FLOOR PLANS

OWNER/CONTRACTOR PRICING, REVIEW, & COORDINATION SET
NOT FOR CONSTRUCTION

Improvements and Alterations at:
THE DANIELS BUILDING
3805 Cutshaw Ave.
Richmond, Virginia

01 2ND-5TH TYPICAL LEVELS

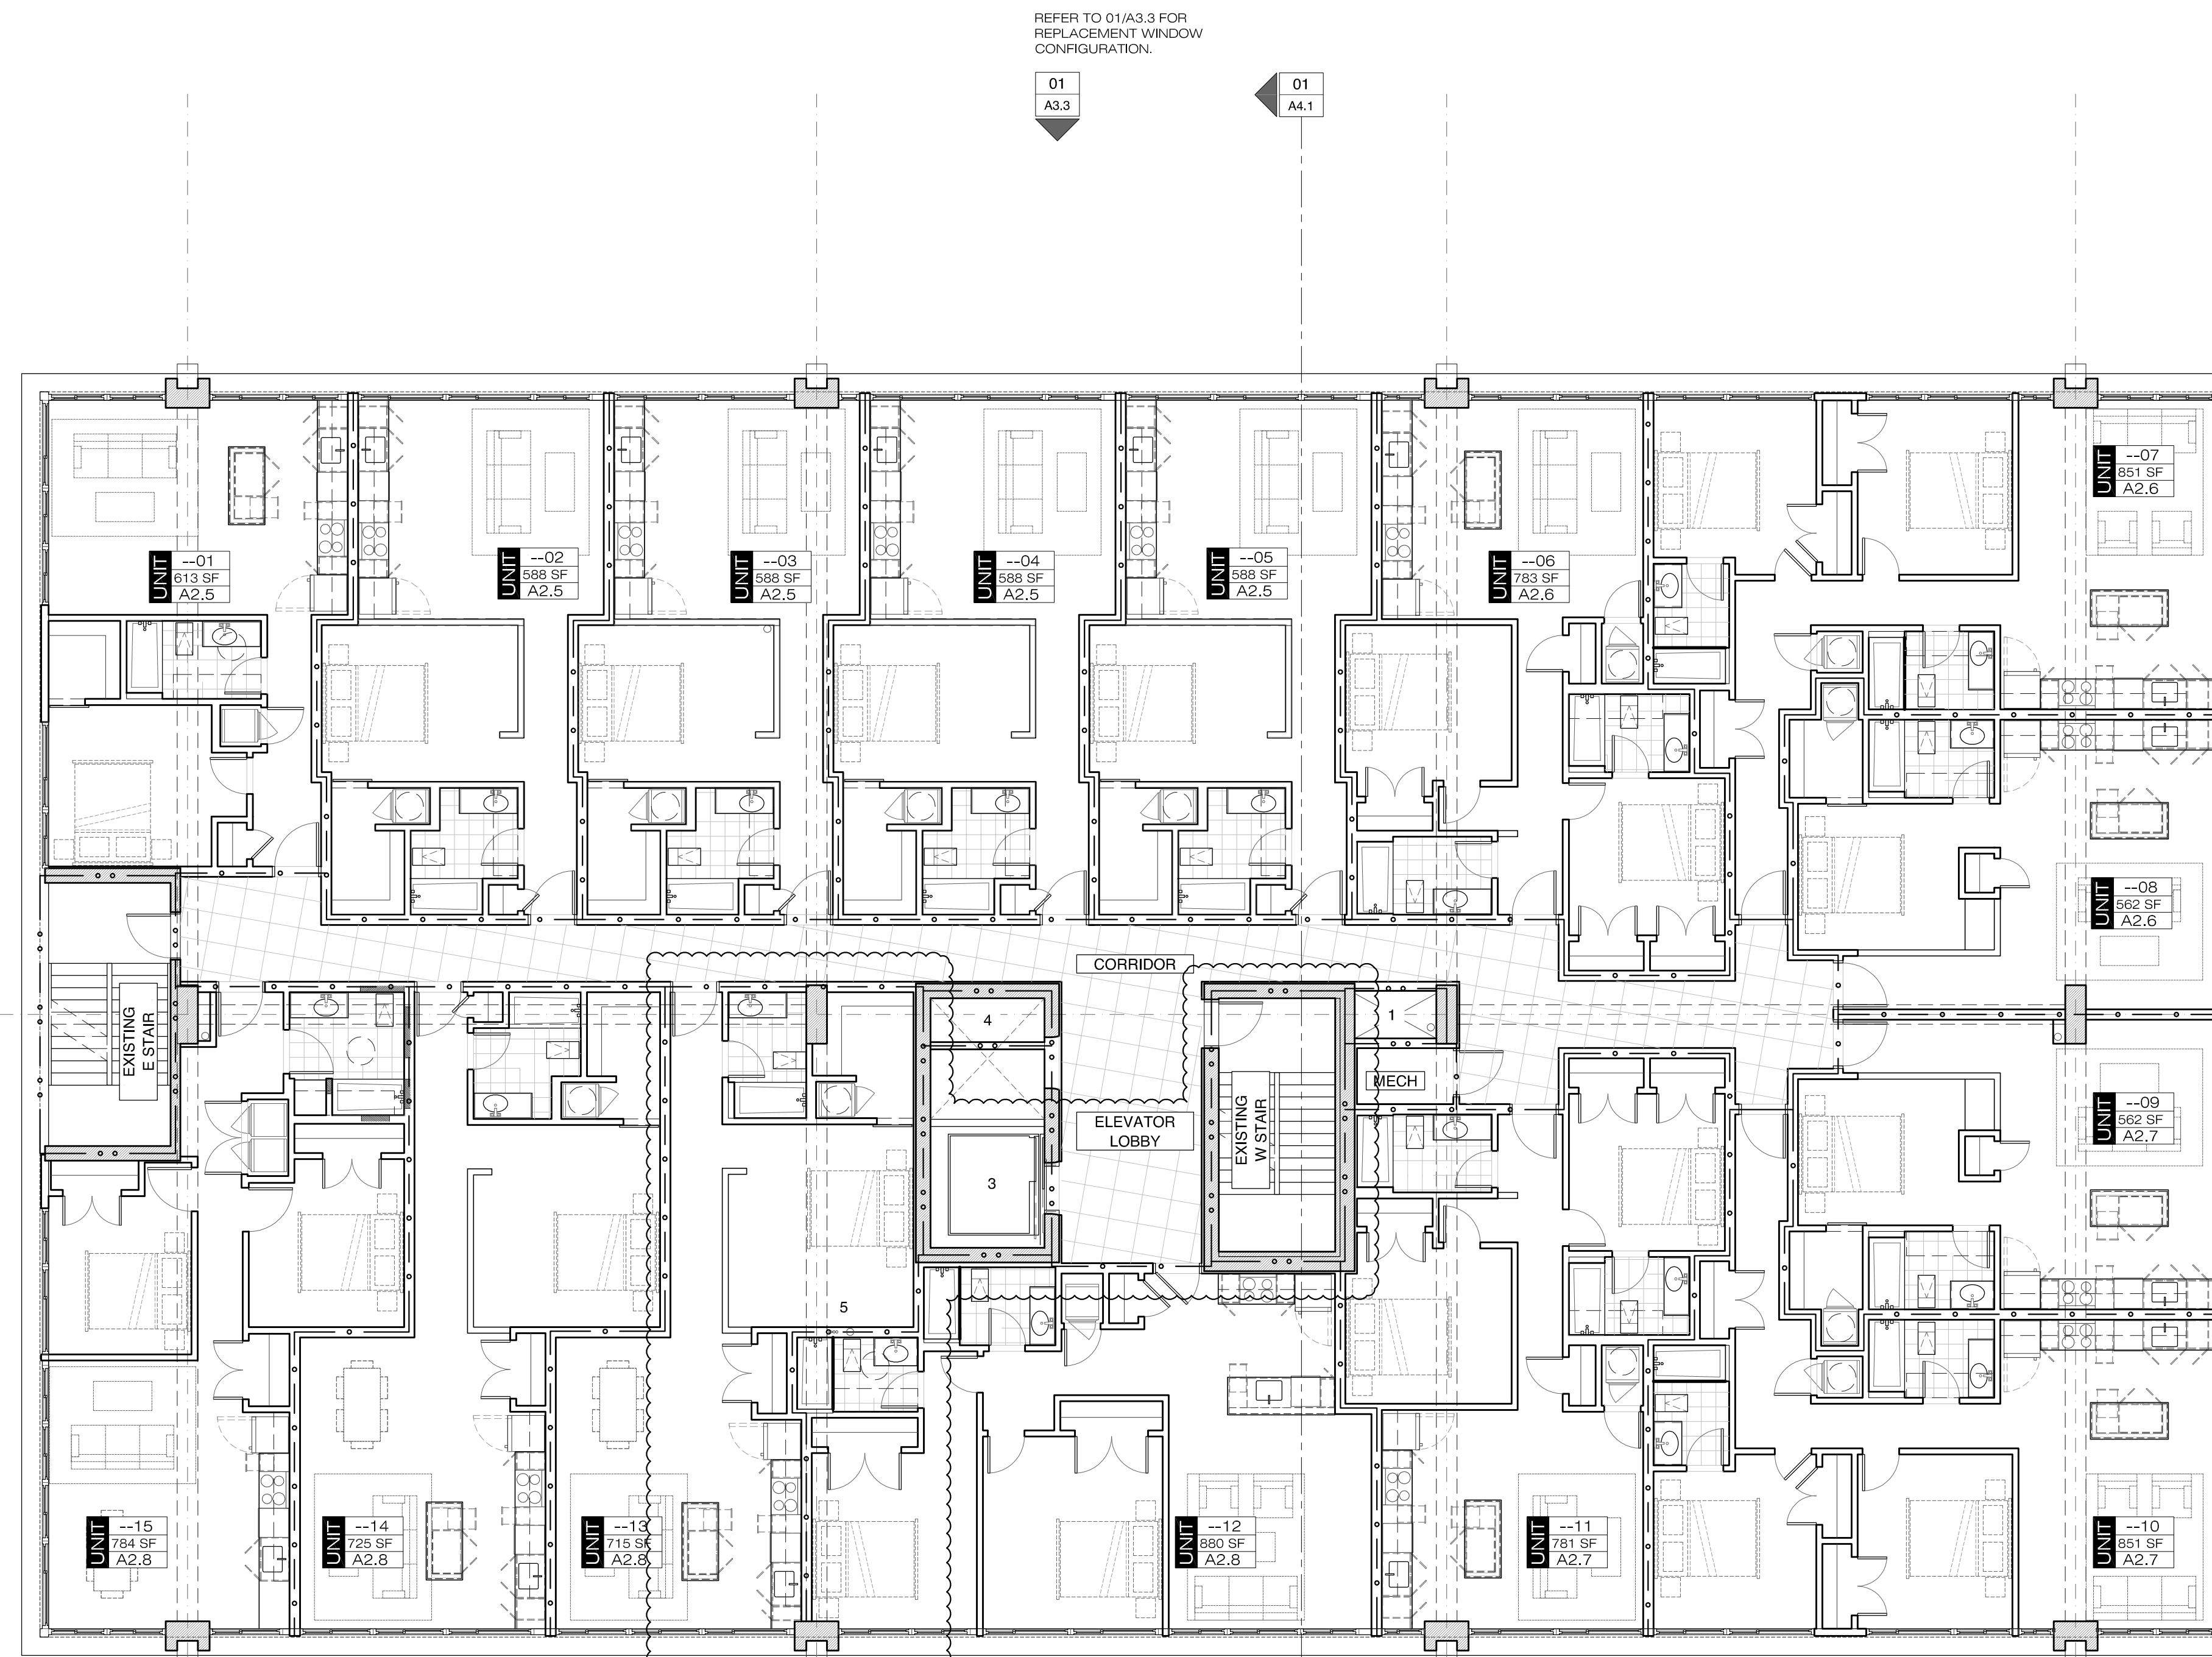
ROOF DECK DELETED 5TH LEVEL IS AFFECTED WITH DELETION OF STAIR FROM ROOF TO 5TH LEVEL. 5TH LEVEL BECOMES IDENTICAL TO LEVELS 2-4.
